LiDAR Quality Assessment Report

SD_Missouri River Lidar Dewberry_2016_D16 - Block 4

NGTOC
2018-06-13
Sarah Klaas

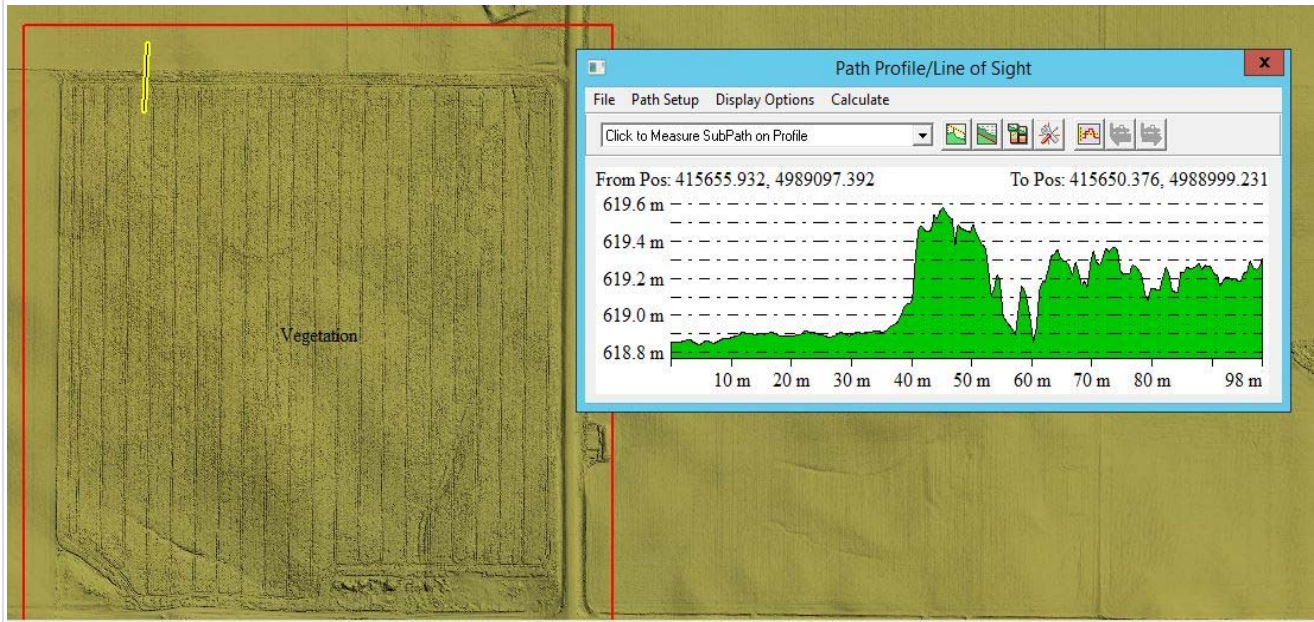
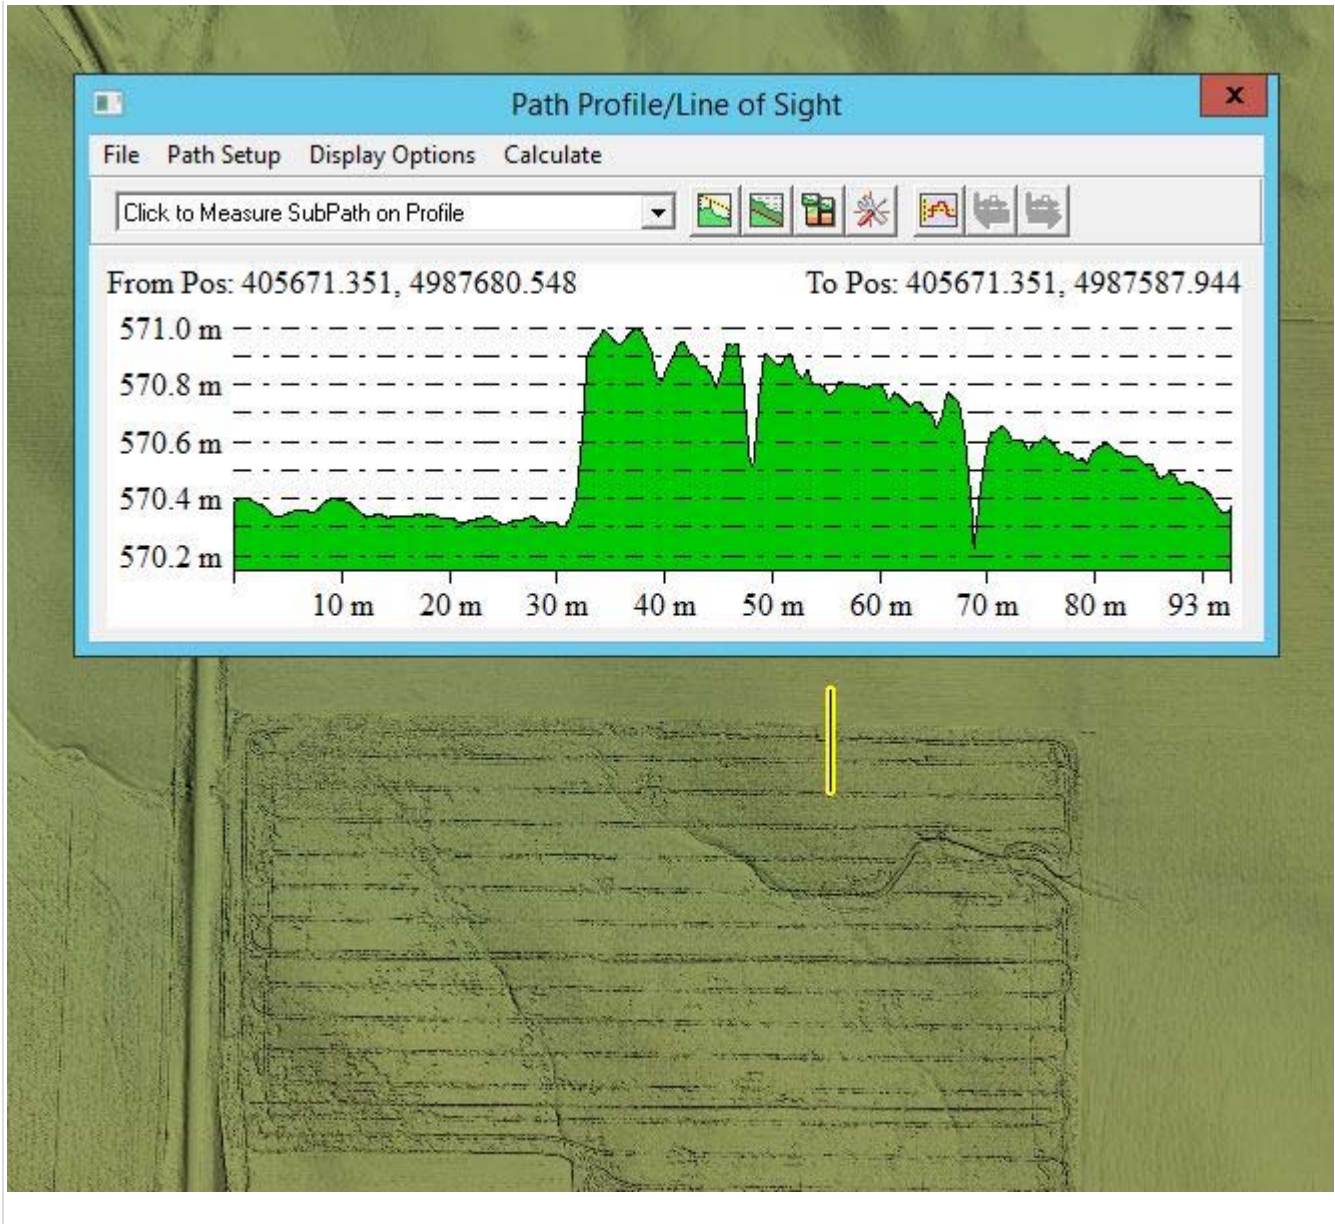
3 errors related to 1 meter tall vegetation in the DEM were found in Block 4, examples can be seen

below. (6/13/2018)
